Re: SE 049-0635 - New Bedford Regional Airport  
Subject: Erosion Control Modification Proposal

### PROPOSED ILS ROAD EROSION CONTROLS

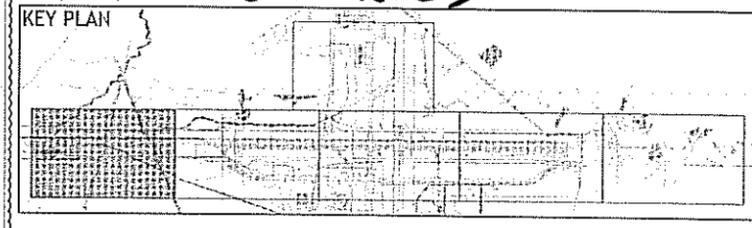
We are requesting that the erosion control measure on the ILS road be changed.

Specifically, the ILS Road at the end of Runway 5 is proposed to be a combination of silt fence and hay bales. The work on the ILS road includes electrical trenching, access to the MALSR lighting and access to the tree clearing area.

The proposal for tree clearing is to transport entire trees to the end area of Runway 5 for processing. Full branched trees are going to be wider than the ILS road and silt fence and hay bales would constantly be dislodged.

The proposal is to replace them with 12" compost filter tubes. These have been shown to provide excellent stormwater treatment and resource protection and will work well in an area where there is little runoff heading to the BMP. Their lower profile will mean less daily maintenance to the BMPs because we anticipate less impact to the BMP during the tree removal.

1. The movable turtle barrier would be relocated to the arch culvert over the west ditch.
2. Turtle sweeps would continue to be conducted on a daily basis in all areas and this area would be monitored multiple times per day.
3. A stock pile of 10 foot length of compost filter sock would be available on site in the event that the tree removal process damages any compost filter tube or any gaps or dislodgements occur.
4. The work areas around the MALSR lighting would continue to hay bale and silt fence combination as specified. These areas are not anticipated to be in the tree removal route.

12" FIBER ROLL

PROPOSED MOVABLE TURTLE BARRIER
